APPLICATION NO.	FILING DATE	FIRST NAMED INVENTOR	ATTORNEY DOCKET NO.	CONFIRMATION NO.
10/561,354	12/19/2005	Edward G. Shifrin	P/826-9	9700
	7590 12/24/200 FABER GERB & SOF	EXAMINER		
1180 AVENUE OF THE AMERICAS			CUMBERLEDGE, JERRY L	
NEW YORK, NY 100368403			ART UNIT	PAPER NUMBER
			3733	
			MAIL DATE	DELIVERY MODE
			12/24/2008	PAPER

Application No.	Applicant(s)				
	10/561,354	SHIFRIN ET AL.				
Office Action Summary	Examiner	Art Unit				
	JERRY CUMBERLEDGE	3733				
The MAILING DATE of this communication app	ears on the cover sheet with the c	orrespondence address				
Period for Reply						
A SHORTENED STATUTORY PERIOD FOR REPLY WHICHEVER IS LONGER, FROM THE MAILING DA - Extensions of time may be available under the provisions of 37 CFR 1.13 after SIX (6) MONTHS from the mailing date of this communication. - If NO period for reply is specified above, the maximum statutory period w - Failure to reply within the set or extended period for reply will, by statute, Any reply received by the Office later than three months after the mailing earned patent term adjustment. See 37 CFR 1.704(b).	ATE OF THIS COMMUNICATION 36(a). In no event, however, may a reply be tim vill apply and will

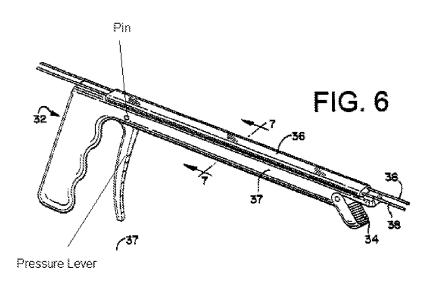
Oberlander further discloses an apparatus for removing said fixing means when it is necessary to perform a post-operative surgical procedure within the thoracic cavity containing: a hollow body (Fig. 6, ref. 36 and 37) (column 7, lines 57-58) provided with a handle (near ref. 32) extending therefrom, and in its lower part with a bifurcated stop (the bottom portions of the two separate halves of the handle); a grasping member (Fig. 8, ref. 34) movably disposed within this body; a pressure lever (Fig. 6 below) pivotally mounted on a pin (Fig. 6 below) within the upper part of the hollow body, this pressure

lever has a handle extending substantially in the same direction as said handle of hollow body (Fig. 6, ref. 36 and 37) (column 7, lines 57-58) and a free end located within the hollow body and operatively connected to said spring-loaded grasping member.

There must be a connection inside that connects the handle to the grasping portion; otherwise there would be no way to operate the grasper with the handle.

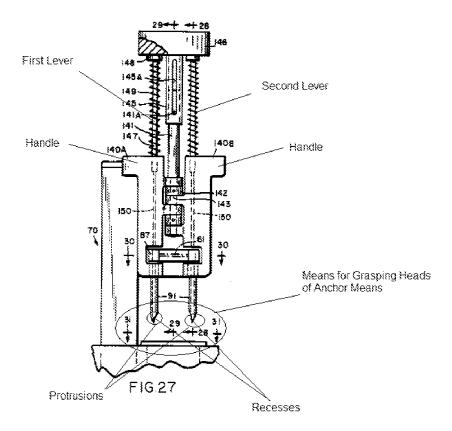
The means for grasping the heads of anchor means are formed as two protrusions facing one another (Fig. 27 below), one of them being disposed at the proximal end of first lever, and the second at the proximal end of the second lever, and these protrusions have, at their free ends, recesses (Fig. 27 below) matching in shape the grooves on the side surface of heads of said anchor means. The fixing apparatus comprises at least one third lever (Fig. 42 below) pivotally connected to said first lever or with said second lever (column 10, lines 44-45) and spring-loaded relative (Fig. 48, ref. 243, 241 and 210) to this first or second lever, said third lever being provided with a handle (Fig. 42 below) at its distal end, and at its proximal end with a means for delivering the fixing means inside said first and said second anchor means (Fig. 42) below), which is shaped substantially as a pusher (Fig. 48, ref. 242, 243 and 186) (column 11, lines 22-28). The fixing apparatus has a means for retaining and by the piece, delivering of fixing means (Fig. 42 below), comprising generally a movable spring-loaded die (Fig. 48, ref. 243, 241 and 210) with slots for disposing these fixing means, this die being adapted to perform stepping linear movement in a guide, which is rigidly connected to said first lever or to said second lever of said fixing apparatus.

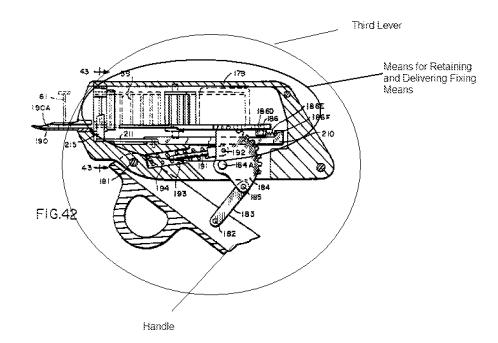
and the second (Fig. 27 below), each of them having a proximal end and a distal end, these levers are pivotally connected to one another (column 3, lines 21-22) (column 3, lines 27-29) and provided with handles at their distal ends (Fig. 27 below), as well as with means for grasping the heads of anchor means at their proximal ends (Fig. 27 below); at least one third lever (Fig. 42 below) pivotally (column 10, lines 44-45) connected to a bearing plate (Fig. 42, ref. 179) rigidly secured on said first lever or said second lever, this third lever is provided with a handle at its free end (Fig. 42 below), and pivotally connected by its middle to the means for delivering the fixing means inside said first and said second anchor means formed substantially as a pusher (Fig. 48, ref. 242, 243 and 186) (column 11, lines 22-28); a means for retaining and by the piece delivering of fixing means (Fig. 42 below) formed substantially as a cartridge enclosing spring-loaded fixing means located right up to one another.

The fixing apparatus contains at least two levers, the first and the second (Fig. 27 below), each of them having a proximal end and a distal end, these levers are pivotally connected to one another (column 3, lines 21-22) (column 3, lines 27-29) and provided with handles at their distal ends (Fig. 27 below), means for mutually fixing the handles when brought together, as well as by means for grasping the heads of anchor means at their proximal ends. The button and button holes can be considered the means for mutually fixing the handles when brought together, since, when the levers are pivoted together, they could be held in that position by the button once the levers are placed through the button holes (column 10, lines 27-33). If the levers are held in position, then so are the handles, which are attached to the levers (Fig. 27, below). The

means for grasping the heads of anchor means are configured as two protrusions (Fig. 27 below) facing one another, one of which is disposed at the proximal end of the first lever, and the second at the proximal end of the second lever, and these protrusions have at their free ends recesses (Fig. 27 below) matching in shape the grooves on the side surface of heads of said anchor means. The fixing apparatus contains a single unit including at least one third lever (Fig. 42 below), a means for retaining and by the piece delivery of fixing means (Fig. 42 below) formed substantially as a cartridge, and a means for delivering a fixing means inside said first and said second anchor means formed substantially as a pusher (Fig. 42 below); this single unit is pivotally (column 10, lines 44-45) connected to the bearing plate rigidly mounted on said first lever or said second lever and is capable of folding back in the vertical plane to provide viewing of said means for grasping the anchor means or returning into operative position with simultaneous rigid fixing of the cartridge at the proximal ends of said first and second levers of the fixing apparatus.
